## **ADDENDUM NUMBER ONE**

**DATE:** August 14, 2017

**SUBJECT:** Addendum Number One to  
Highway Z and D Sidewalk Improvements  
Project No. M15-7143  
STP – 5414 (621)

DATE:	8-14-17	RETURNS:	ADDENDUM NO. 1	DWN. BY:	SMR	APPD. BY:	ESK
SCALE:	NO SCALE	PROJ. NO.:	M15-7143	DWG. NO.:	DE-4

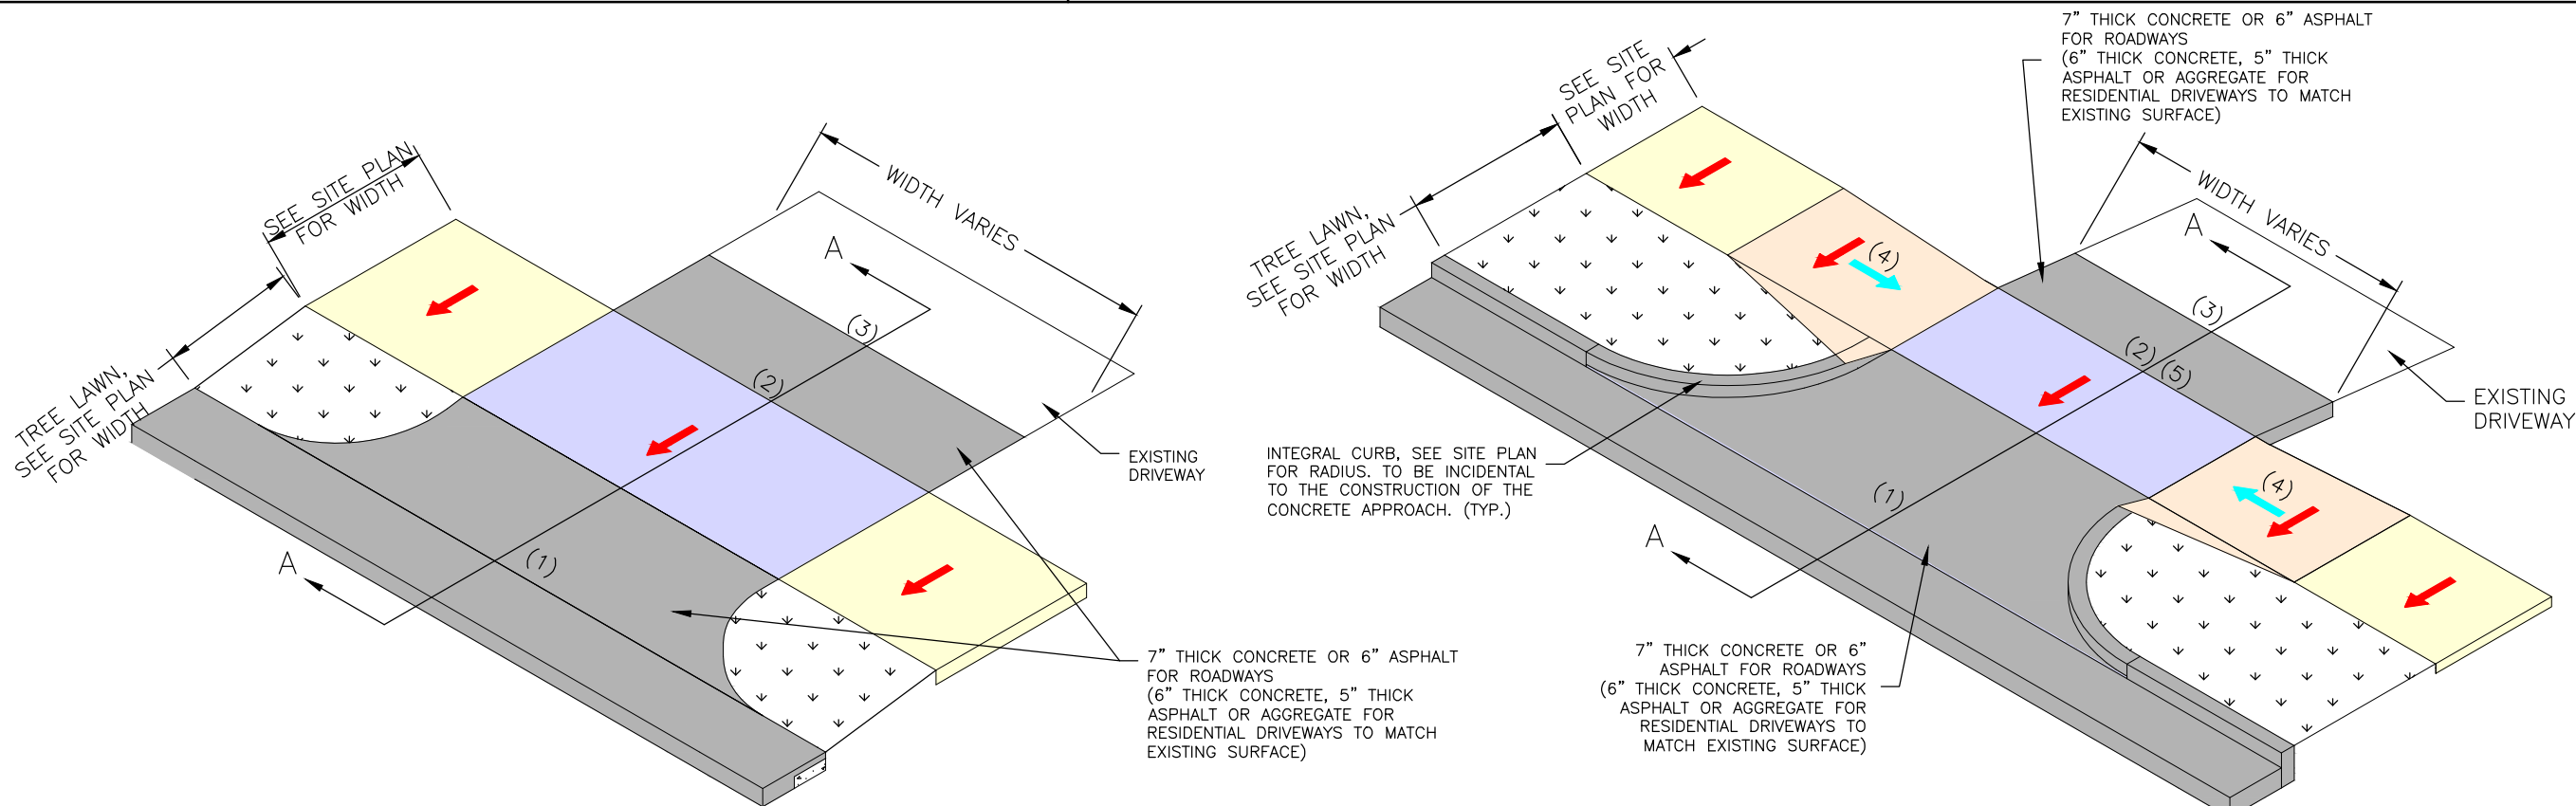
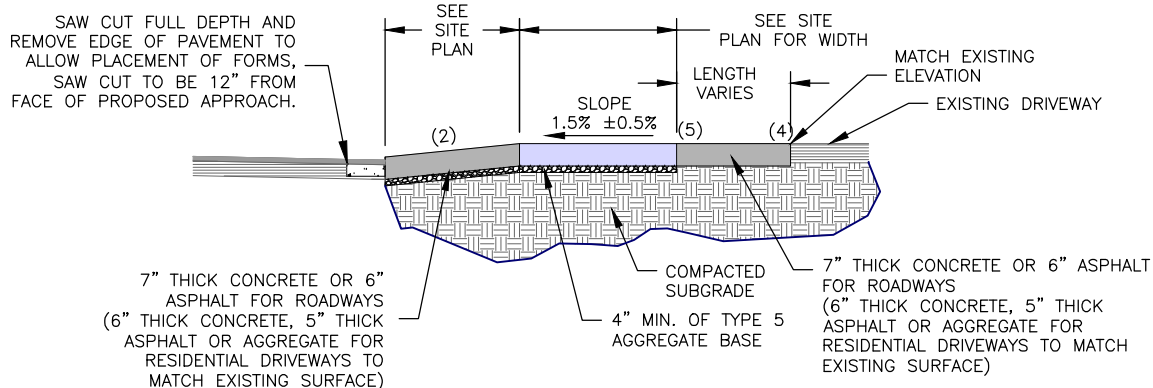
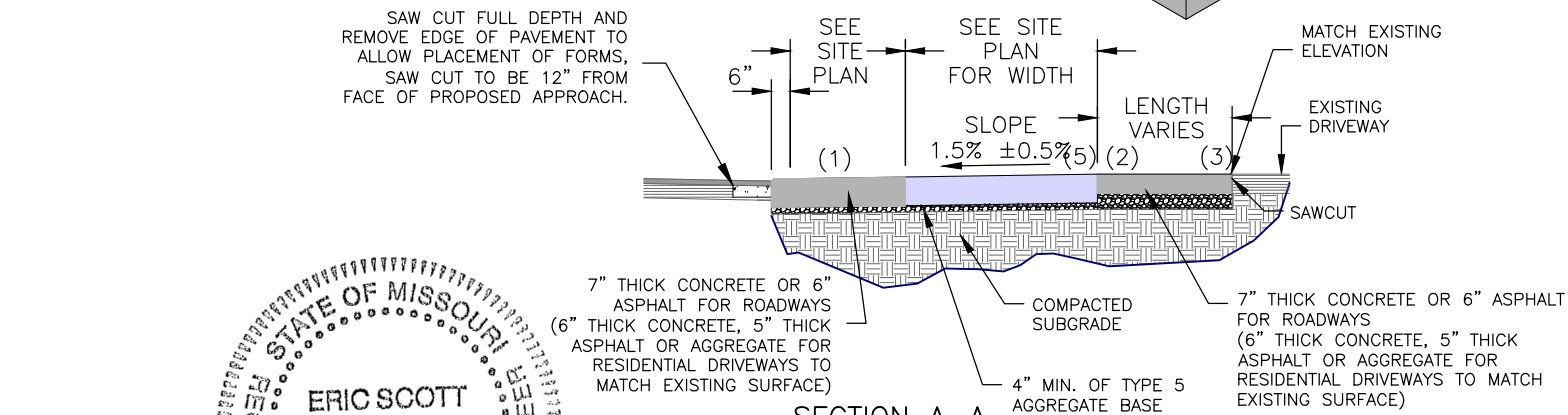
5. All steel products used on the project will be required to follow the Buy America Specifications. This includes storm sewer piping and structures.
6. Concrete sidewalks shall be thickened through commercial entrances to a thickness of not less than 7" of Concrete on 4" of prepared aggregate base or 6" of Asphalt on 8" of prepared aggregate base. Concrete sidewalks shall be thickened through residential driveways to a thickness of not less than 6" of concrete on 4" of prepared aggregate base or 5" of asphalt on 8" of prepared aggregate base. The limits of asphalt/concrete

repair are graphically shown on the plans and shall include all of the area within the sawcuts. A revised DE-4 is attached for reference.
